GRAMOPHONES

22GF 110/02S/03S/04S/17S
02X/03X/04X/17X
02L/04L/15L

22 GF 110

Information

Fig. 1

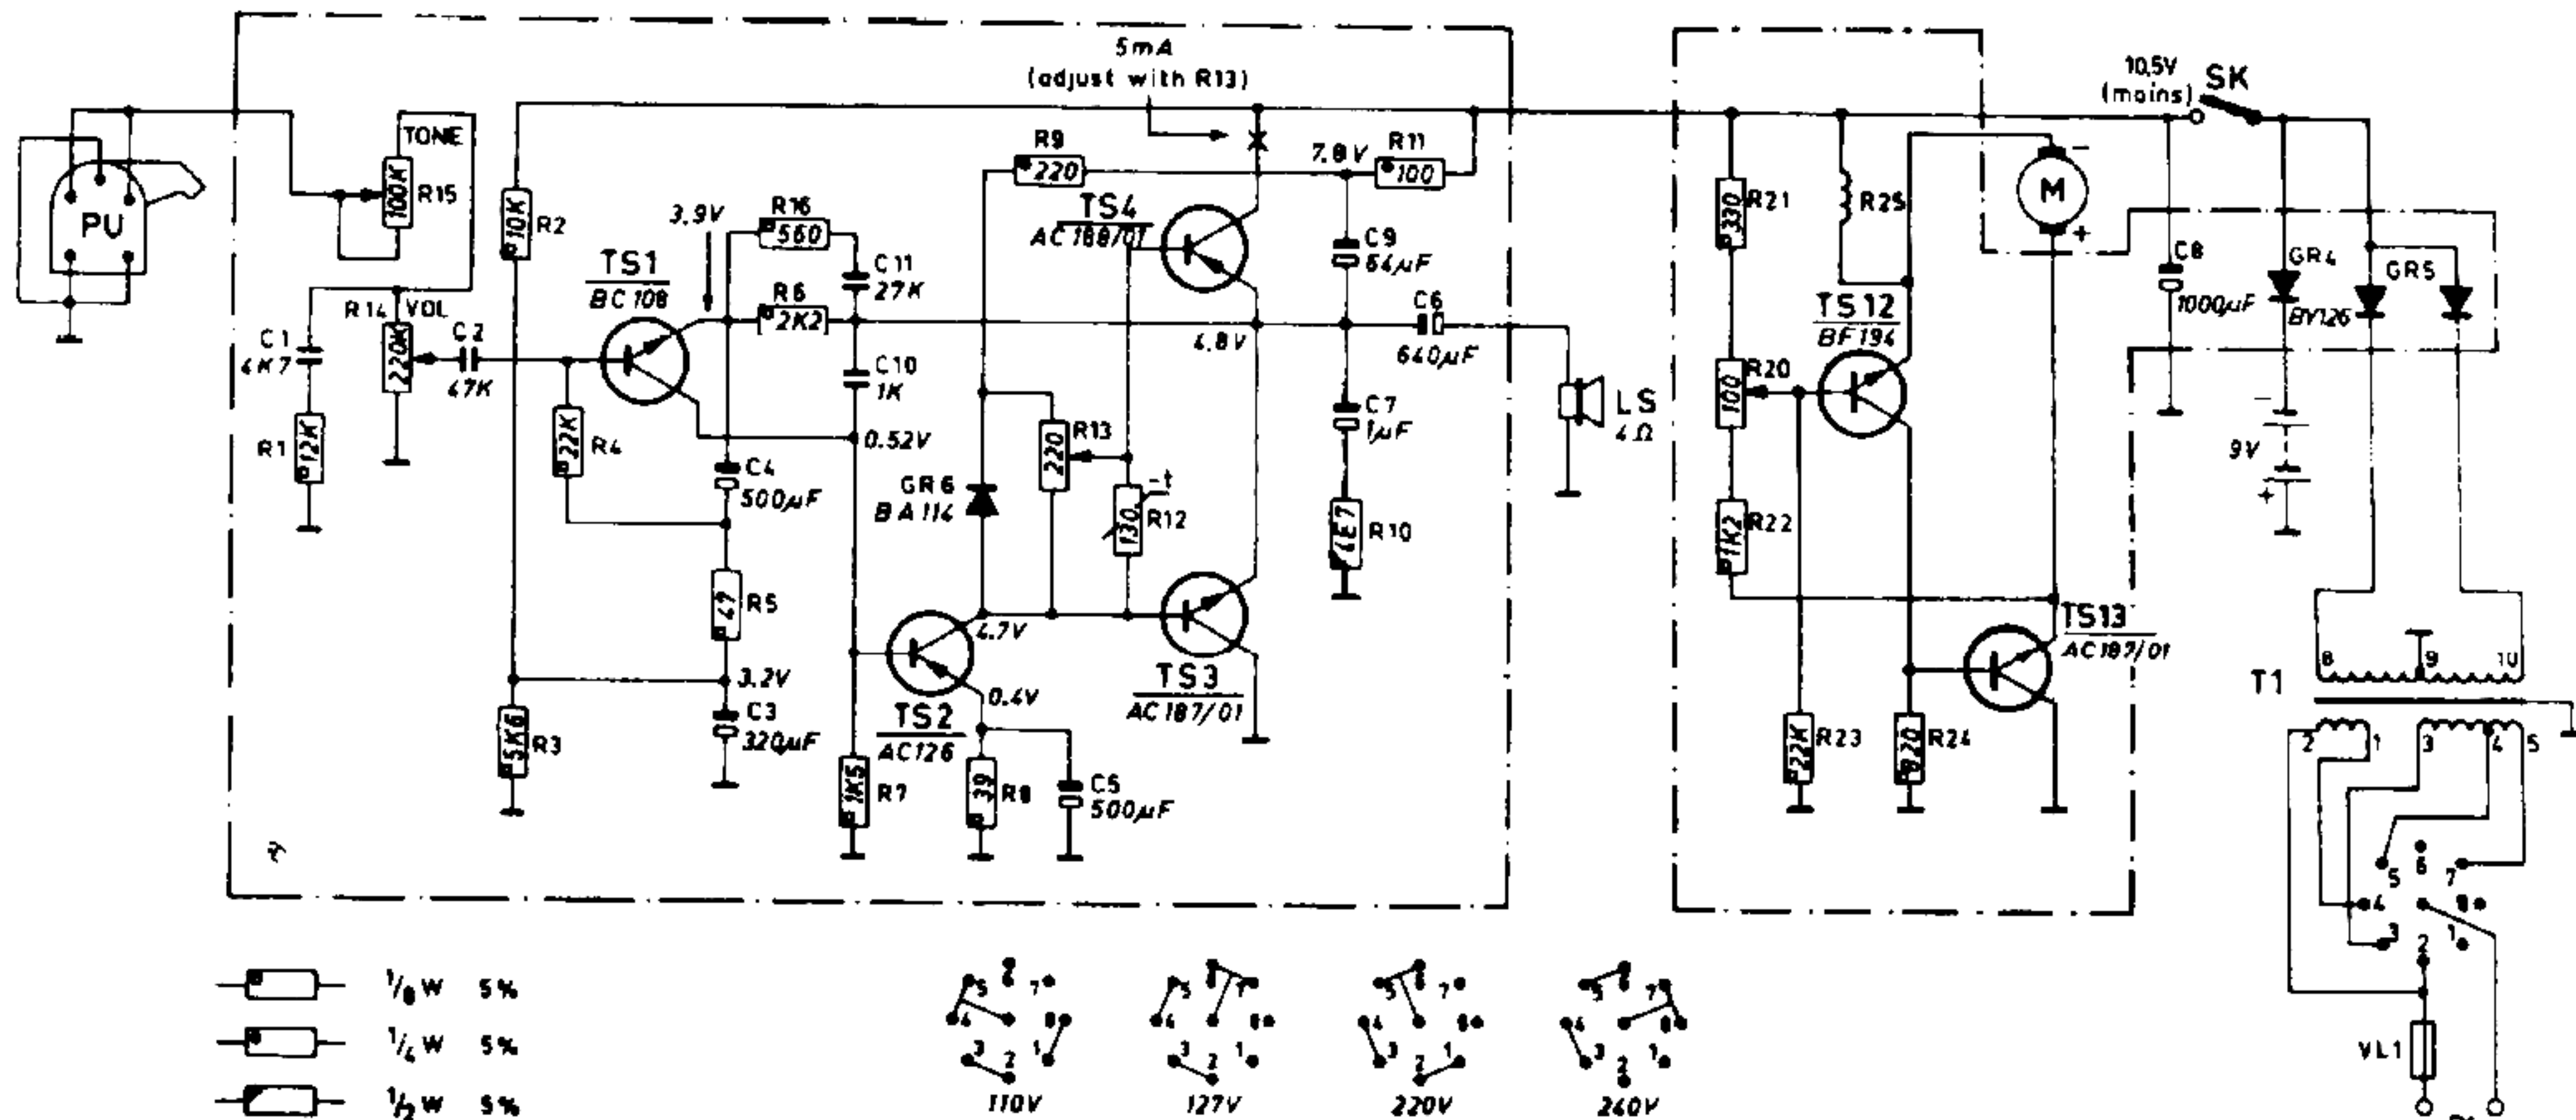
During the production of the 22 GF 110 three different supply transformers were applied:

1. The transformer drawn in Figs. 1 and 2 of the Service Notes.
This transformer is no longer supplied.
2. The transformer, which is supplied under code number 4822 145 30069. This transformer replaces the transformer mentioned above and is identical to it with the exception of the connection points, which are positioned differently. For this, see Fig. 1 below.
3. The transformer drawn in Fig. 2 below. This is supplied under code number 4822 145 30057.

Fig. 1

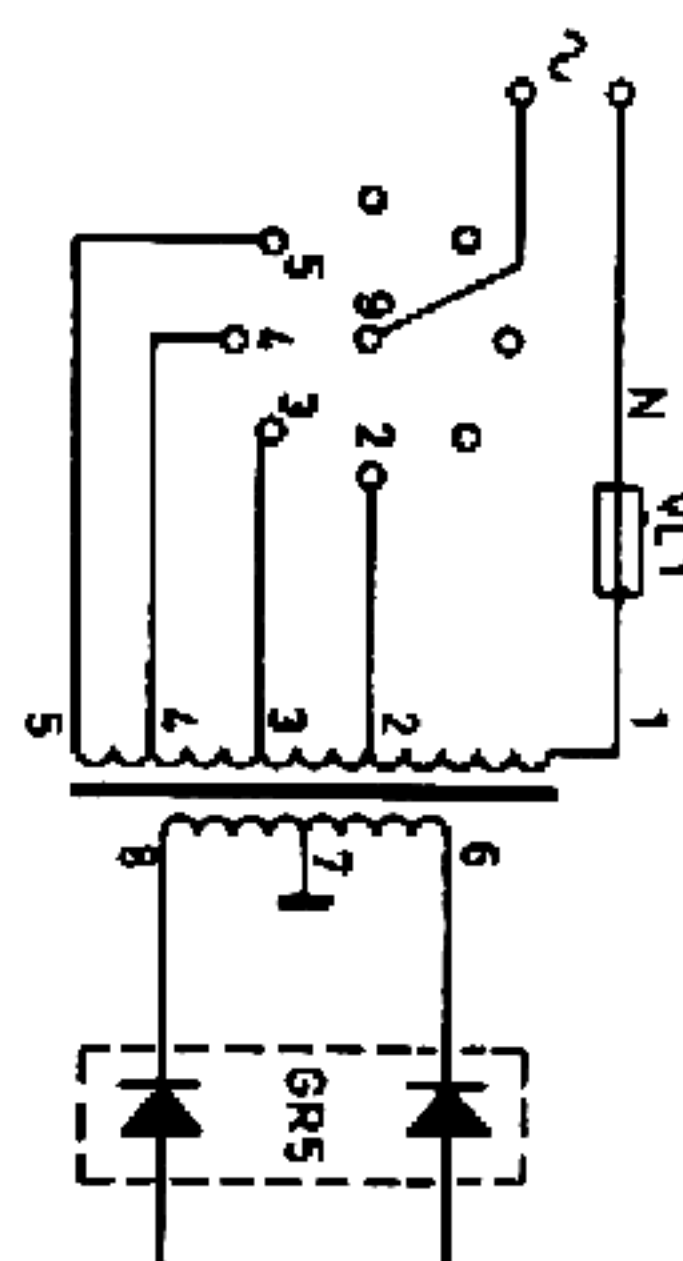
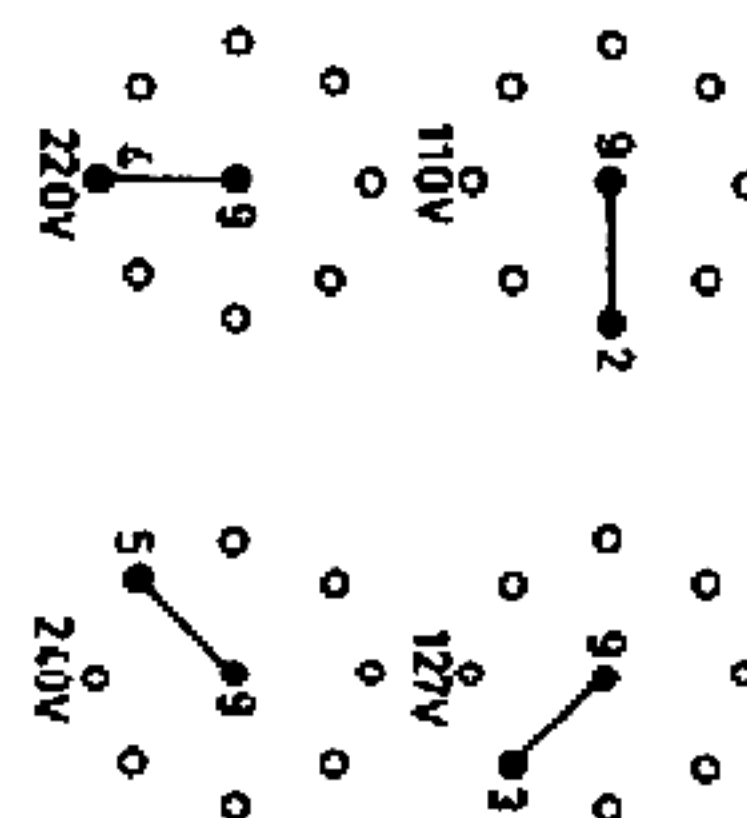
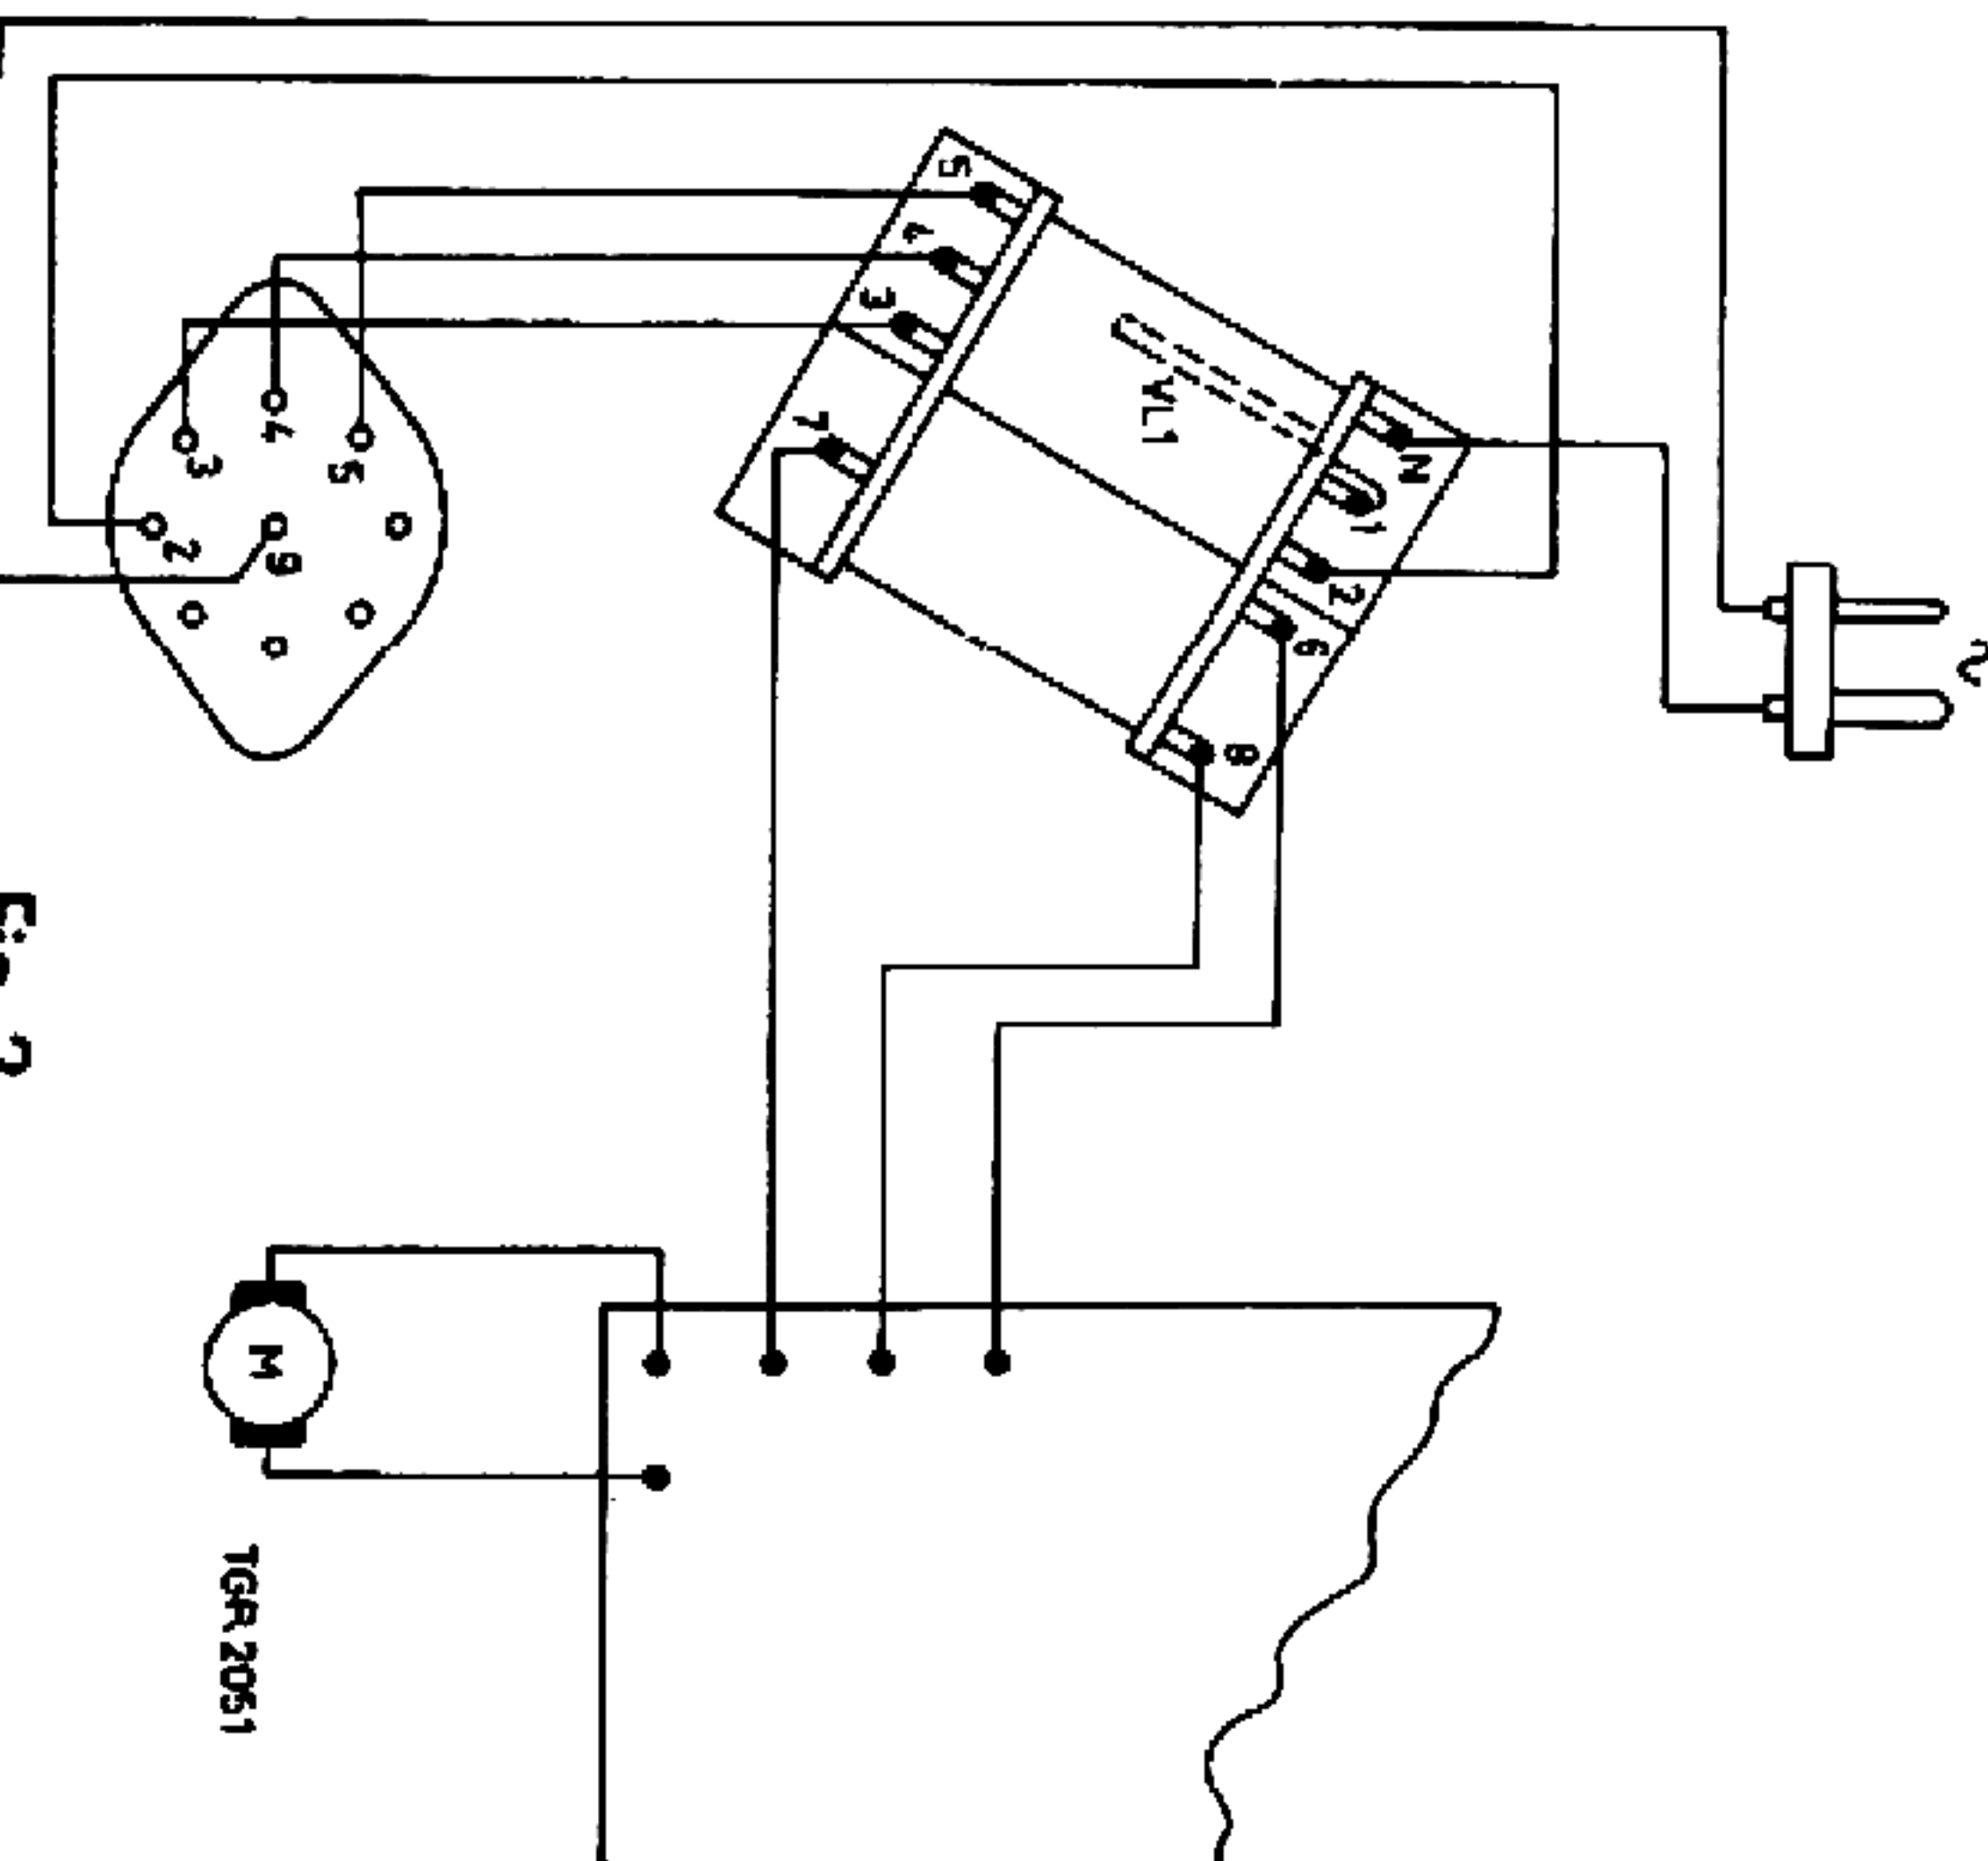
For this transformer a different voltage adapter is used with only one interconnection in the adapter knob.

Code number adapter knob: 4822 263 30076

Code number adapter plate: 4822 263 40024.
